HOWARD COUNTY HISTORIC PRESERVATION COMMISSION
ELlicott City Historic District ■ LAWYERS HILL Historic District
3430 Court House Drive ■ Ellicott City, Maryland 21043

October Minutes

Thursday, October 7, 2021; 7:00 p.m.

HPC-21-38 – 8085 Main Street, 8095 Main Street, 8109-8111 Main Street, 8113 Main Street, Ellicott City

Figure 6 - Proposed area of demolition at 8085 Main Street

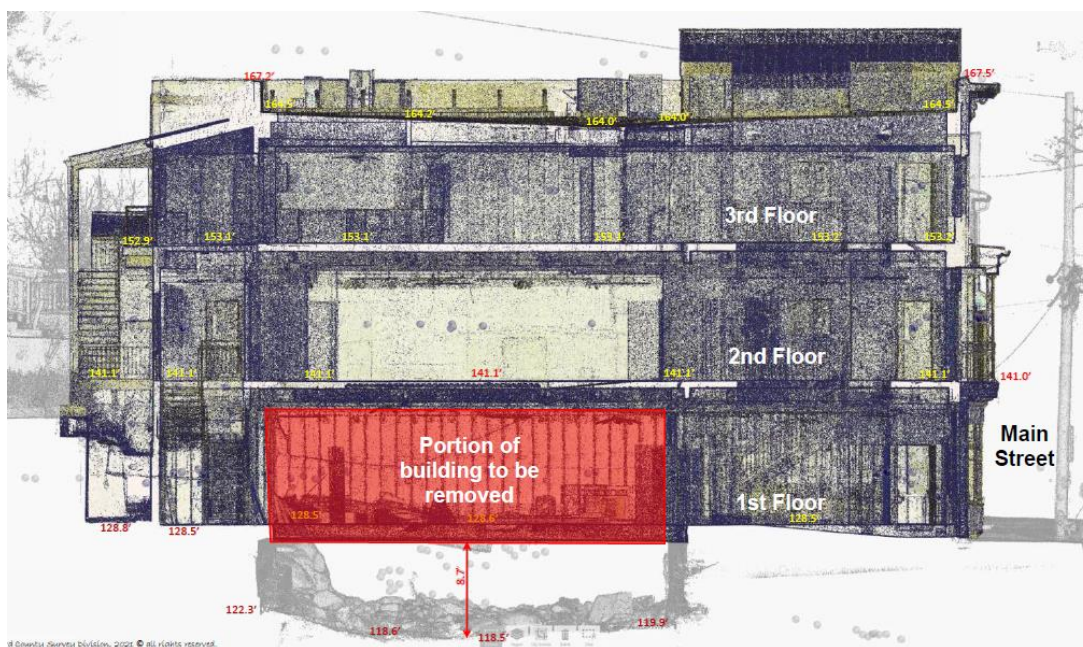
Mr. Hollenbeck discussed 8085 Main Street, a 3-story building with a former basement that was infilled with flowable fill so that it no longer contains the basement space. He explained the County proposes to remove the rear two-story portion, which was an addition to the original terra cotta portion (which they propose to retain). Mr. Hollenbeck explained the prior property owner retained the land with the deck across the stream and the County does not own that. Mr. Hollenbeck said the rear section proposed for removal was heavily damaged in 2016 flood. The County believed it was originally supported with three trusses, one was destroyed in 1999 fire, the previous owner said one was destroyed in 2016 flood and the third retained for aesthetics. The portion they propose to remove was constructed from platform framing, which limits their ability to maintain any portion above the stream channel. He explained they have the opportunity to expose views of the former grist mill race, which is not visible right now, but it was a feature they found which they could expose and restore.

Figure 7 – Proposed area of demolition at 8095 Main Street

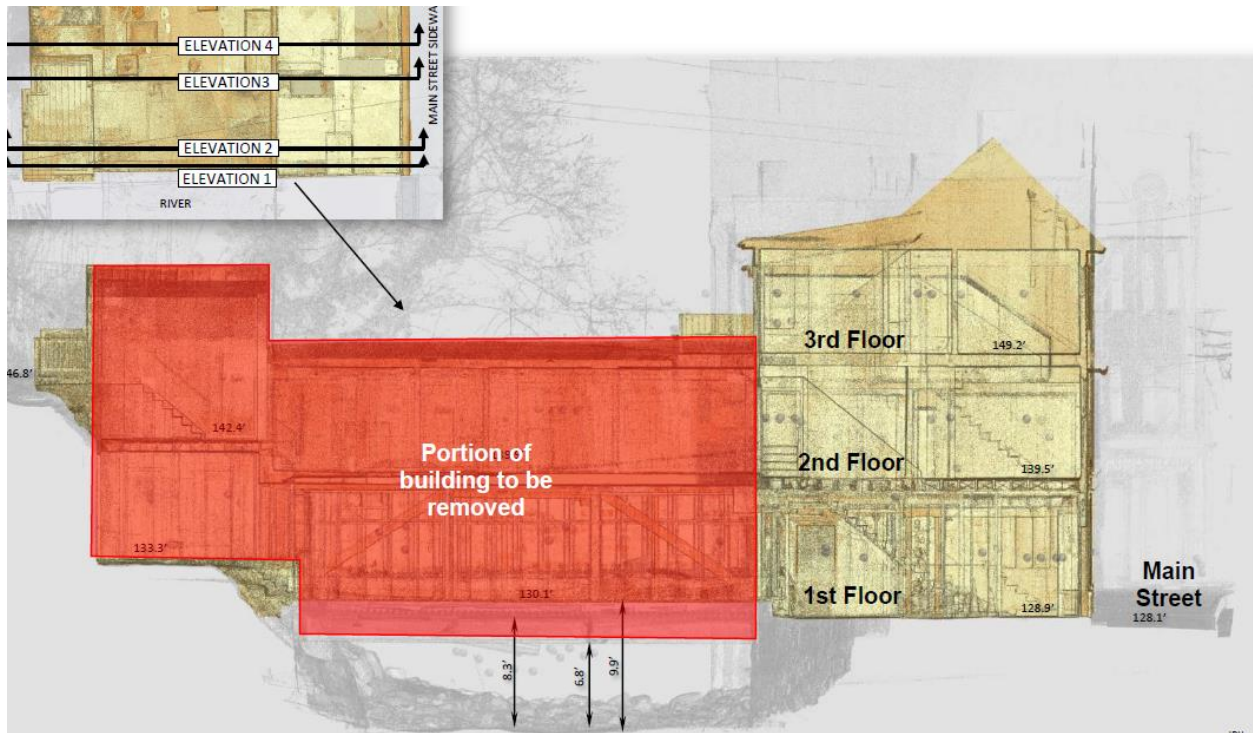
Mr. Hollenbeck said that 8095 Main Street was constructed in the late 1990s/early 2000s when the former building destroyed by fire in 1999. He explained they propose only to remove a portion of 1st floor and the 2nd and 3rd floors will remain. Mr. Hollenbeck said the first floor will be usable. Mr. Hollenbeck explained the contemporary construction method of this building, which allows them to retain the upper floors, while removing the rear of the first floor. He said the building was designed for the 100-year floodplain. He said this building was designed for the 100-year floodplain and is a good example of the problem with active floodproofing methods. He explained that the building has a flood door and during the first flood no one knew where it was and during the second flood, it was so heavy that the sole occupant of the building could not move it, so the building took on water. He stressed the importance of getting the water level to the point where active flood proofing is not needed, because it cannot be implemented in the amount of time these types of flood allow.

Figure 19 – Example of terracing and stonework at Falls Park on the Reedy, Greenville, SC, Google Streetview 2014

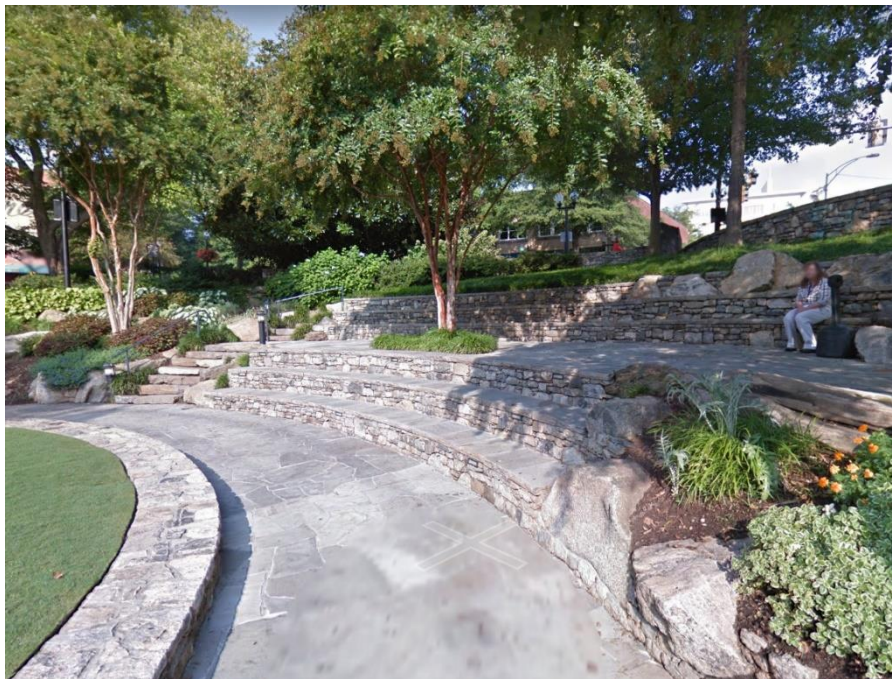
Newspaper articles about the 1999 fire indicated that the lack of rear access to the buildings along Main Street was a significant impediment to containing the fire. If possible, any incorporation of hydrants and emergency access (such as level surfaces where possible) would be beneficial.

Alternate arrangement of the ramp switchbacks and terracing could allow for more usable parkland, which could include incorporation of picnic tables, terracing, benches and usable lawn. This would allow more gathering space during emergency events and more space for passive recreational opportunities.

Staff Recommendation to the HPC: Staff recommends the HPC provide Advisory Comments on the rear treatments of the building and the creation of a pocket park based on the standards set forth in §16.607 of the Howard County Code and its adopted Guidelines.
